Serial No. 10-063A
LIC/JG/R0
Docket No. 50-305
License No. DPR-43

DOMINION ENERGY KEWAUNEE, INC.
KEWAUNEE POWER STATION
SUPPLEMENT AND RESPONSE TO REQUEST FOR ADDITIONAL INFORMATION:
LICENSE AMENDMENT REQUEST 236, AUTOMATIC OPERATION OF
TRANSFORMER LOAD TAP CHANGERS (TAC NO. ME4011)

**RESPONSE TO REQUEST FOR ADDITIONAL INFORMATION:
LICENSE AMENDMENT REQUEST 236
AUTOMATIC OPERATION OF TRANSFORMER LOAD TAP CHANGERS**

CS-SI-5R6R-6-ICS-0-2 (Bus Voltages TAP 3R)
Minimum Voltage for a 1.465% Pre-trip to Post Generator Trip Voltage Drop

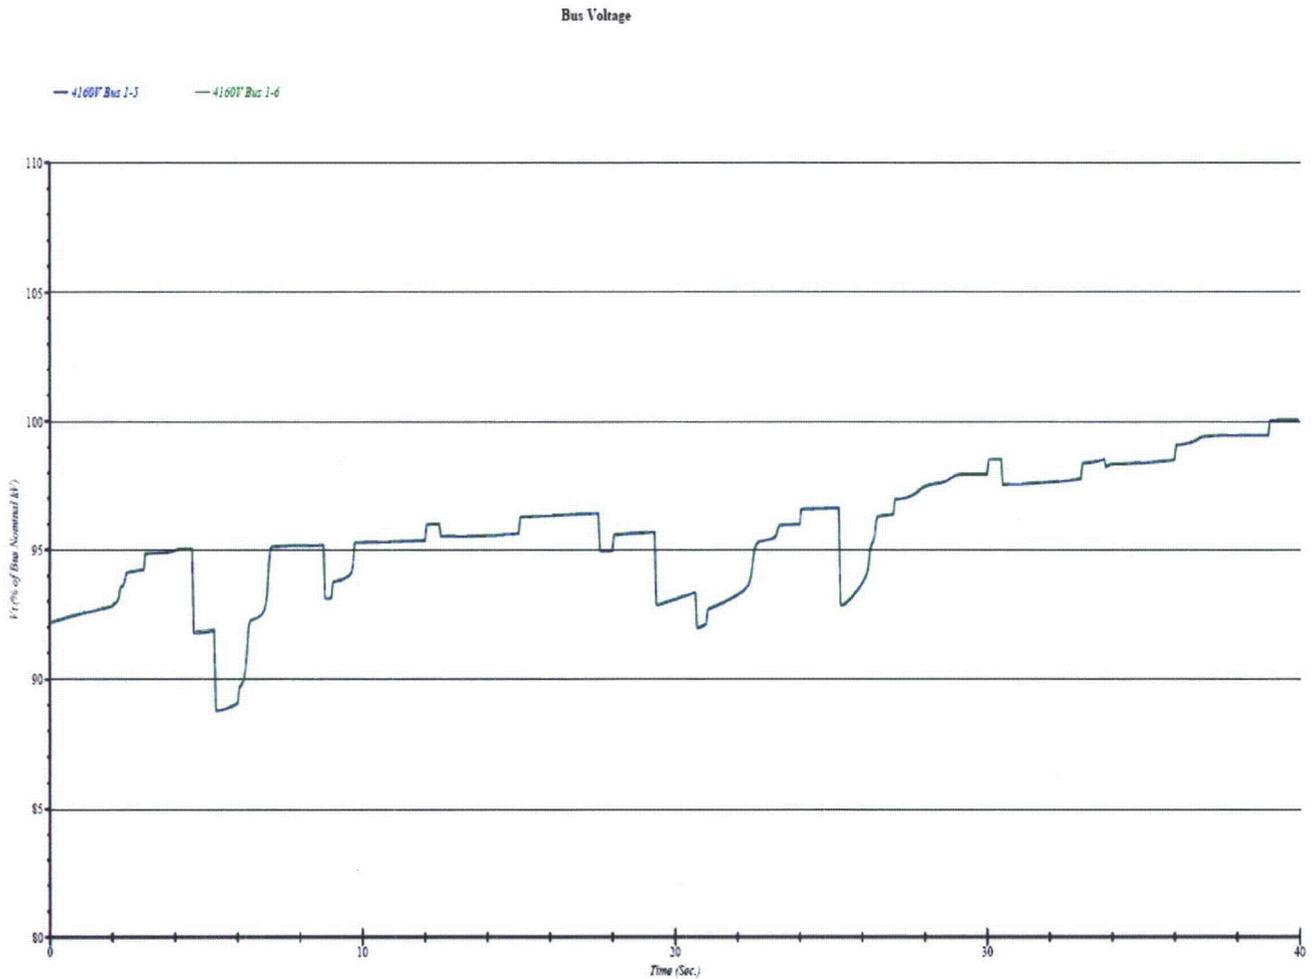
Bus 1-5 is normally supplied from the TAT and Bus 1-6 is normally supplied from the RAT. Thus, no bus transfer is required for the engineered safety features in the event of a unit trip. The plant was designed with an automatic bus transfer feature. Verify that a single failure of the bus transfer scheme will not result in transfer of the Busses 1-5 and 1-6 to a single source of offsite source during a design basis event.

ETAP runs were performed to verify the initial tap position (post event) based on the pre-event tap position (prior to generator trip and SI sequence initiation); and, to establish that the degraded voltage relaying (DVR) would not actuate. Based on analyses performed by American Transmission Company (ATC – transmission operator for KPS), if KPS loses both of its 345kV lines or both T10 and T20 345/138kV transformers (related to the two 345kV switchyard lines); or, if both Point Beach Nuclear Power (PBNP) units are unavailable; or, if Q303 (345kV) and F84 (138kV) transmission lines are both out of service, then it is possible that the maximum change in switchyard voltage due to a KPS unit trip would be from 1.82% to 2.76%. Therefore, for the above

Absence of these worst case conditions would result in a much smaller resultant voltage change. The ATC analyses show that other possible limiting switchyard configurations would result in a maximum voltage drop of 1.465% or less. DEK plans to request that ATC provide a programmed load/voltage forecast warning indication to KPS upon the system forecasting a 1.46% or larger drop in voltage at KPS (due to KPS unit trip). In the event that a larger than 1.46% drop in voltage is forecasted, KPS operators have the capability to manually transfer Buses 1-3 and/or 1-4 to the RAT. This anticipatory transfer would cause the upstream RAT supply transformer (RST) LTC to raise taps and account for the additional Bus 1-3 and/or Bus 1-4 load prior to the trip and thereby decrease the 4kV voltage drop associated with the non-safety related bus transfer at the time of a unit trip. Thus, DVR actuation would not be expected to occur, and the offsite power source (RAT supply) would be maintained.

Voltage profile graphs of the associated ETAP analyses results are provided (for information) in Figures 1 through 7 below. These graphs show that voltage does not decrease below 95% of nominal bus voltage for more than 6 seconds. Although the DVRs themselves actuate, their associated time delay relays do not time out. Thus, no bus stripping signal is initiated and offsite power remains available.

Figure 8
CS-SI-5R6R-6-ICS-0-2 (Bus Voltages at Normal)

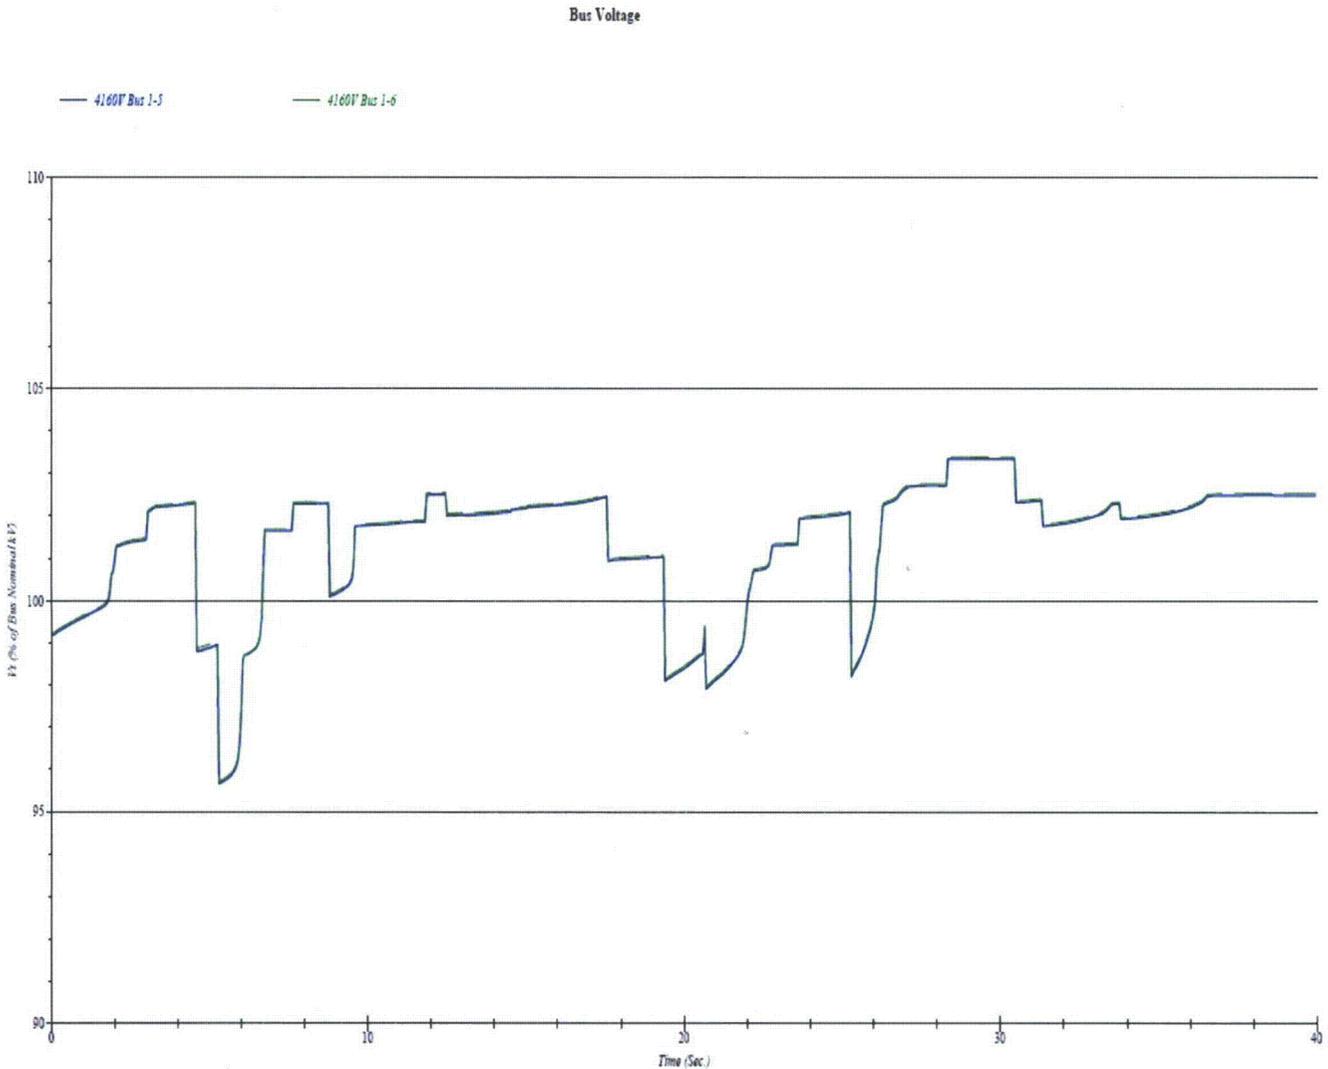
The LAR also states that Buses 1-1 and 1-2 are connected via bus main breakers to the main auxiliary transformer (MAT) and RAT. Buses 1-3 and 1-4 are also connected via bus main breakers to the MAT and RAT. These buses supply power to the normal balance-of-plant auxiliaries. The Updated Final Safety Analysis Report figures in Chapter 8 indicate that the breakers connecting these busses to the RAT are normally open. The safety-related Bus 1-6 is normally connected to the 'X' winding of the same RAT and the Bus 1-5 is normally connected to TAT. The licensee has verbally indicated that the grid is not stable if the 138kV system degrades by 10 percent, the load tap changer (LTC) limit for voltage correction, and it is therefore unlikely that the plant will be operating with the LTCs at the upper limit. In the event of a safety injection signal resulting in plant trip and transfer of Busses 1-1 and 1-2 to the 'Y' winding and 1-3 and 1-4 to the 'X' winding of the RAT, provide a detailed analysis of the interaction of the automatic LTCs and the safety bus voltages with accident loads sequencing for the following conditions:

A voltage graph resulting from ETAP analysis runs based on the 138kV system voltages at normal is provided for information in Figure 8 below. Operation of the KPS electrical system is based on the FERC Category A grid limit. The analysis used the FERC limit of +/-5% voltage (Category A) as the grid limit. The ETAP runs that were generated for the response to RAI Question 2 are bounding (evaluated both safety buses being supplied by one source, which is conservative) and can be applied in the Question 3 request to illustrate the adequacy of safety-related bus voltages for -5% voltages. The near identical response of the normal (Figure 8 below) and extreme voltage cases (See Question 2, Figures 1 – 7) reflects the capability of the LTC to adjust to a wide range of grid conditions.
